**Report Type:** DA Access Report

**Site Address:** 297 Bringelly Road Leppington

# ACCESS REPORT

This Access Compliance Report is to accompany a Development Application for the development proposed at **297 Bringelly Road Leppington.**

**Building A- Basement 01 showing 17 accessible parking spaces.**  
**15 spaces allocated to the Adaptable units (1 to each adaptable unit),**  
**1 Accessible parking space for Residential visitor and**  
**1 Accessible parking space for Commercial visitor.**

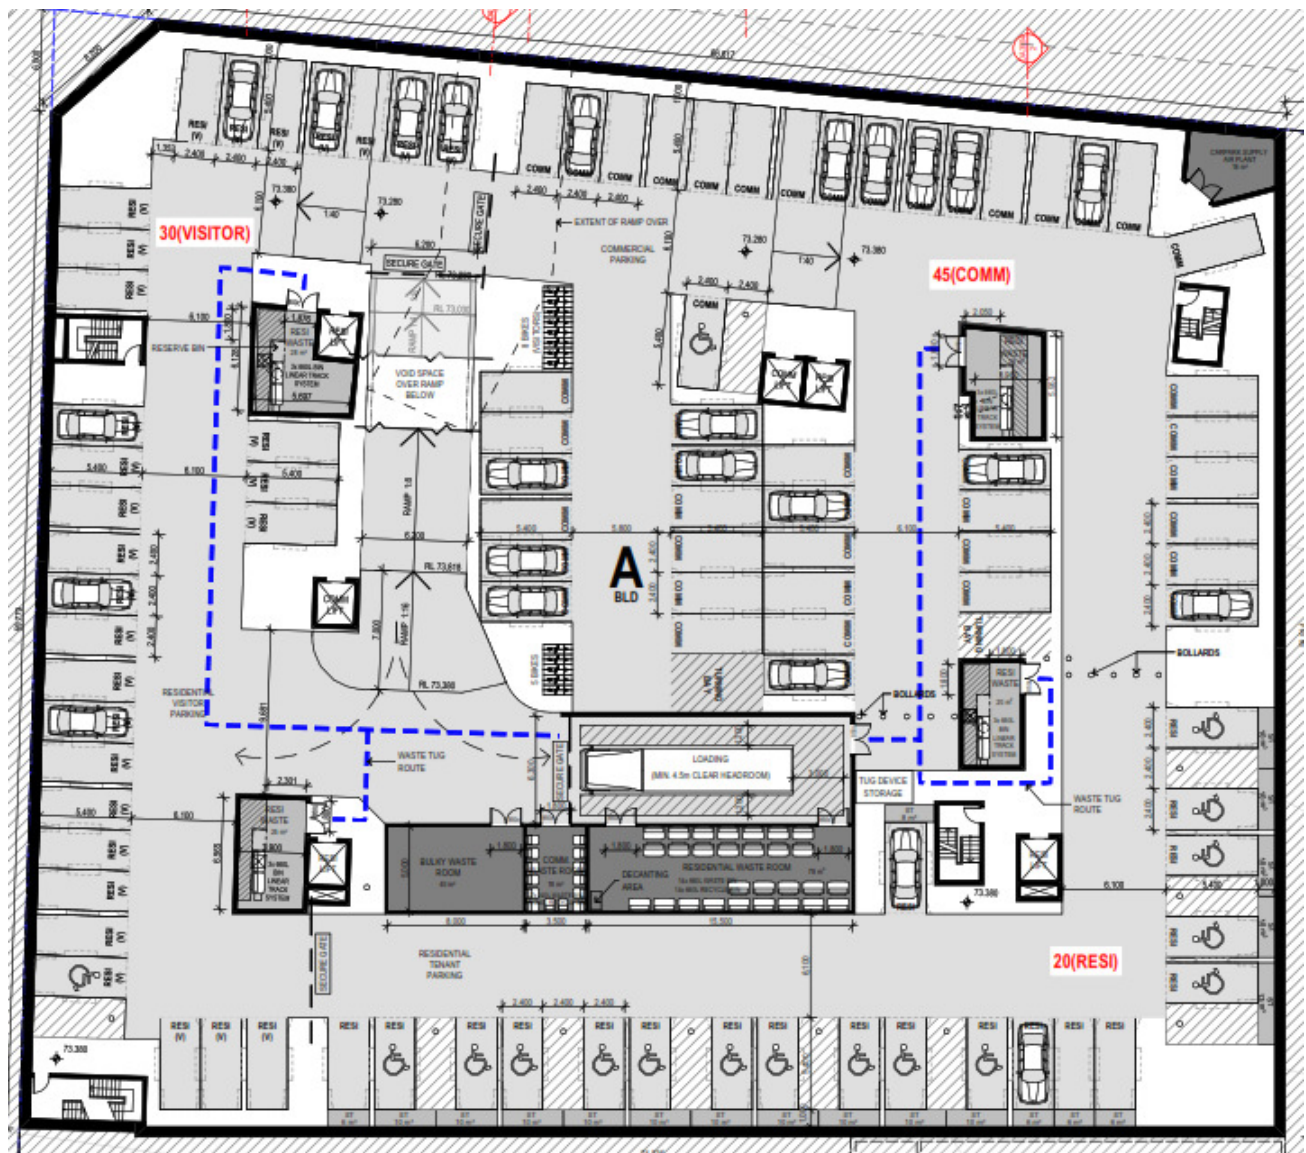
<p>One accessible parking space is required to be allocated to each of the Adaptable units.  <b>Note:</b> The lift that provide access to the adaptable units are to be linked to the allocated accessible parking space by means of an accessible pathway.            Detailed features of the accessible parking spaces are to be verified at CC stage of works.</p>				Adaptable units required/ provided	Accessible parking allocated to Adaptable units	Accessible parking allocated to residential visitors	<b>Building A</b>	15	15	1	<b>Building B</b>	12	13	1	<b>Total</b>		<b>28</b>	<b>2</b>
	Adaptable units required/ provided	Accessible parking allocated to Adaptable units	Accessible parking allocated to residential visitors																
<b>Building A</b>	15	15	1																
<b>Building B</b>	12	13	1																
<b>Total</b>		<b>28</b>	<b>2</b>																
<b>Requirement</b>	<b>Class 5</b> - 1 Accessible car parking space per 100 carparking spaces <b>Class 6</b> - 1 Accessible car parking space per 50 carparking spaces (up to 1000 spaces) and additional 1 Accessible car parking space per additional 100 spaces provided																		
<b>Compliance Comments</b>	Complies. <b>Building A-</b> 1 Accessible commercial visitor parking spaces has been provided. <b>Building B-</b> 1 Accessible commercial visitor parking spaces has been provided. Detailed features of the accessible parking space to be verified at CC stage of works.

**Building B- Basement 01 showing 15 Accessible parking spaces.**

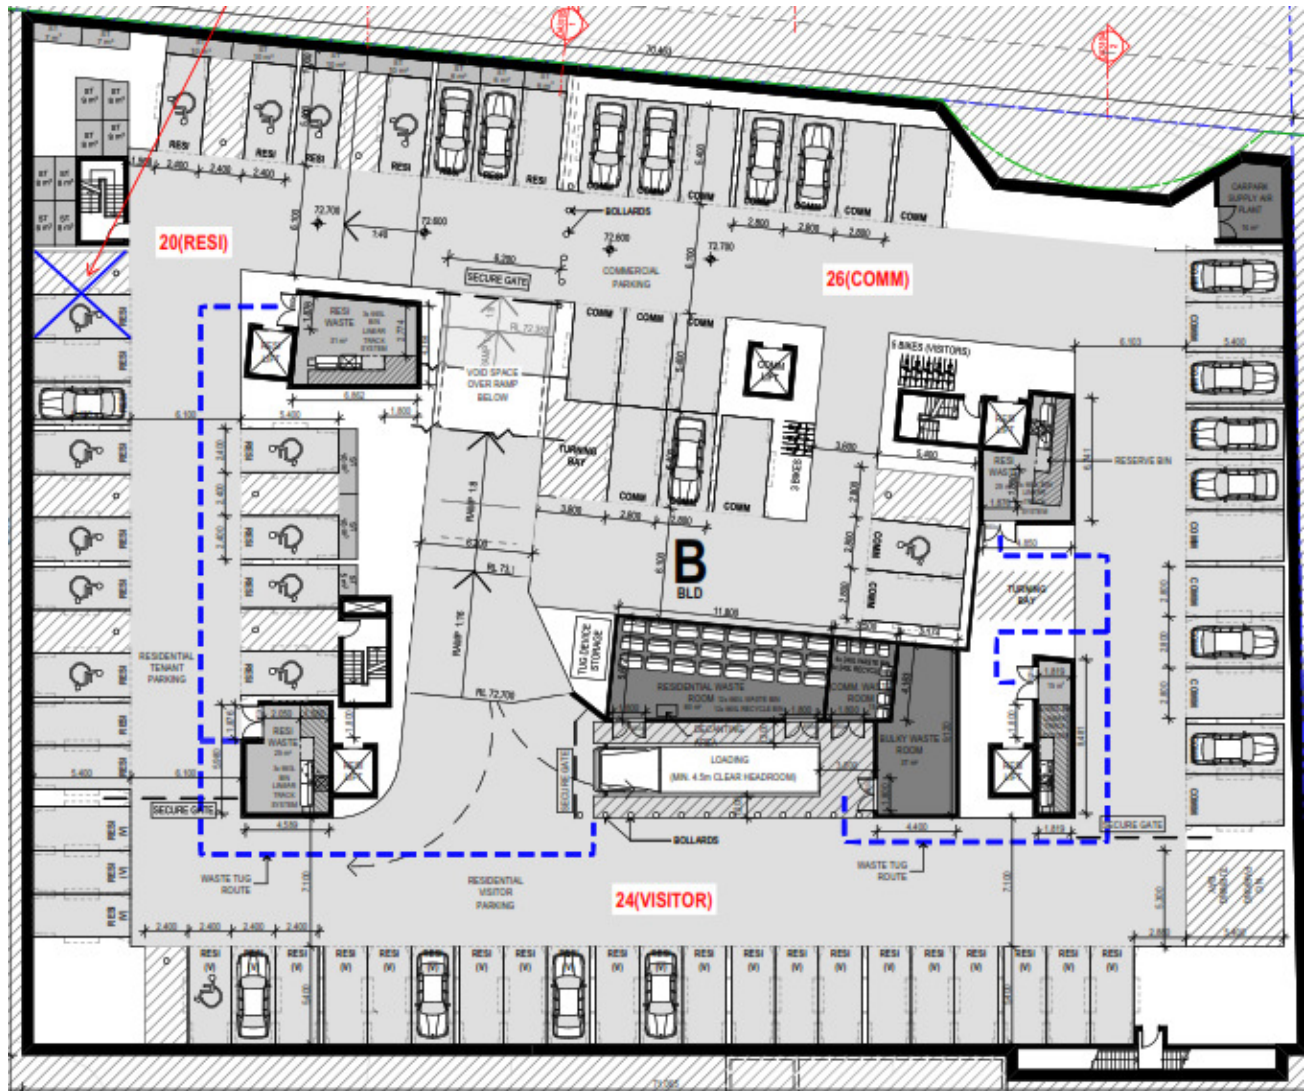
13 spaces allocated to 12 Adaptable units (1 to each adaptable unit), Note: this can be reduced at CC.  
 1 Accessible parking space for Residential visitor and  
 1 Accessible parking space for Commercial.

**Typical layouts** Pre-adaptation layouts shown below (note: some units are a mirror image)

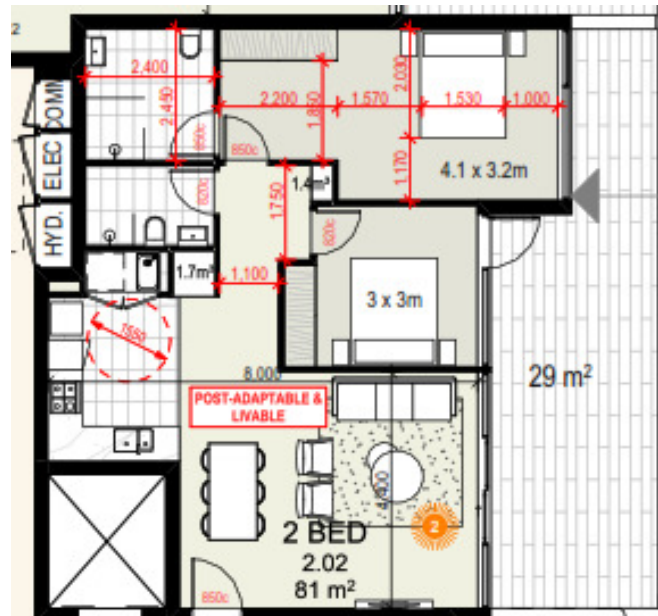
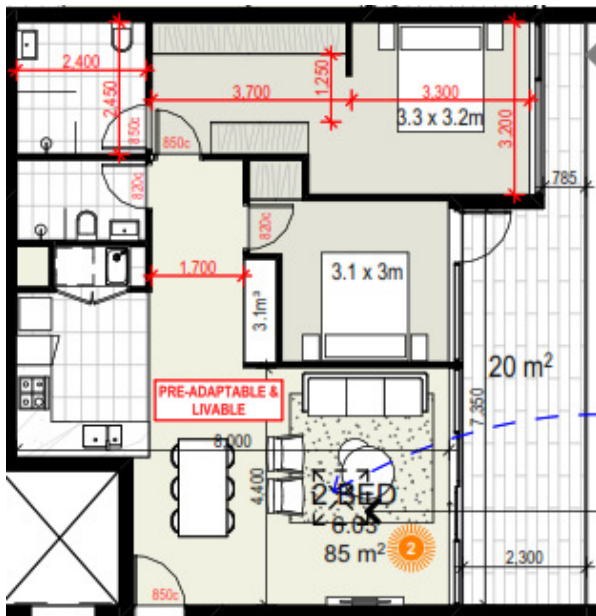
**Note:** In the above layout if 900x1200 space is not achieved in front of the WC pan in the main bathroom, clear of the door swing, then in that case, a cavity slider door is to be used instead of a hinged door at pre-adaptation.

- The space of 900x1200 in front of the pan is to be clear of door swing or shower screen.
- Note that ALL internal passageways are required to be 1M clear when measured from skirting to skirting so allow for the same.
- To comply with Livable, the wet areas are to be such that flush transition is available. One option to achieve this is to recess the floor slab.

### Post Adaptation bathroom layout shown

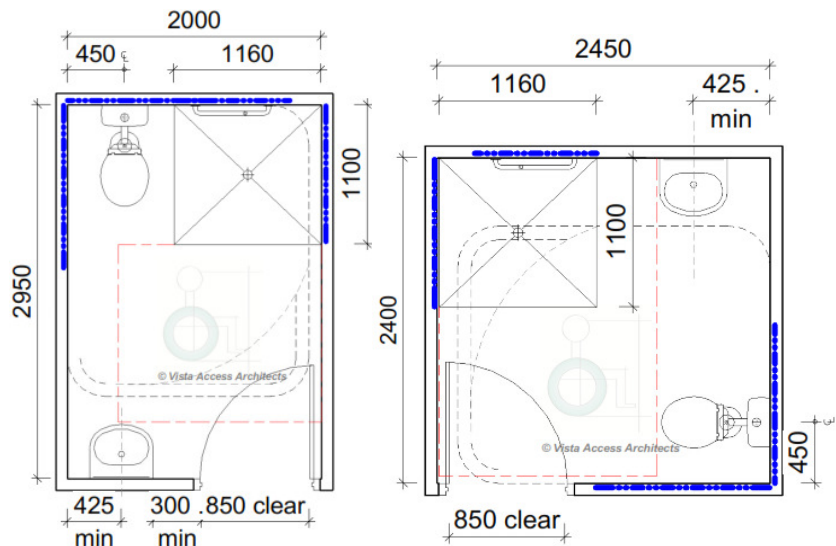
- Provision for bathroom area with Circulation spaces of Shower and WC (including fixtures) to comply with AS1428.1.
- Note that wall reinforcements and waterproofing details to comply with AS4299

Complies  
A bathroom with minimum space of 2Mx 2.95M or 2.3Mx2.7M or 2.4Mx2.45M is achievable. Wall reinforcement details to be verified at the CC stage.

### Wall reinforcement requirements at Pre-adaptation

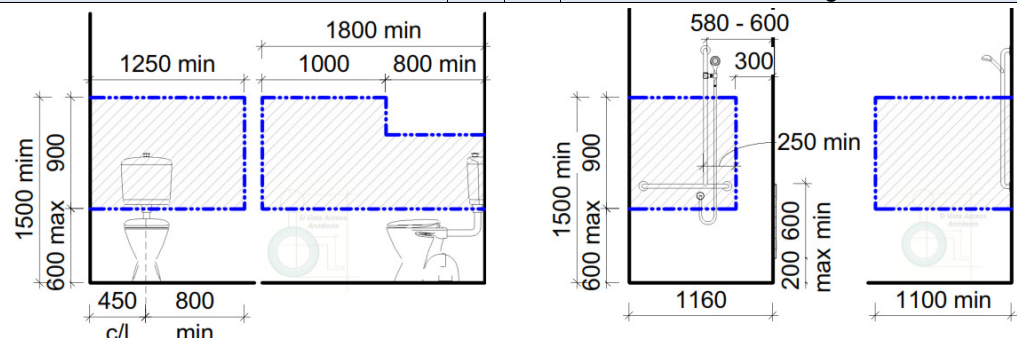
Reinforcement requirements for the Adaptable unit for WC and shower (in post-adaptive position) showed hatched. Refer to AS4299 for further details.
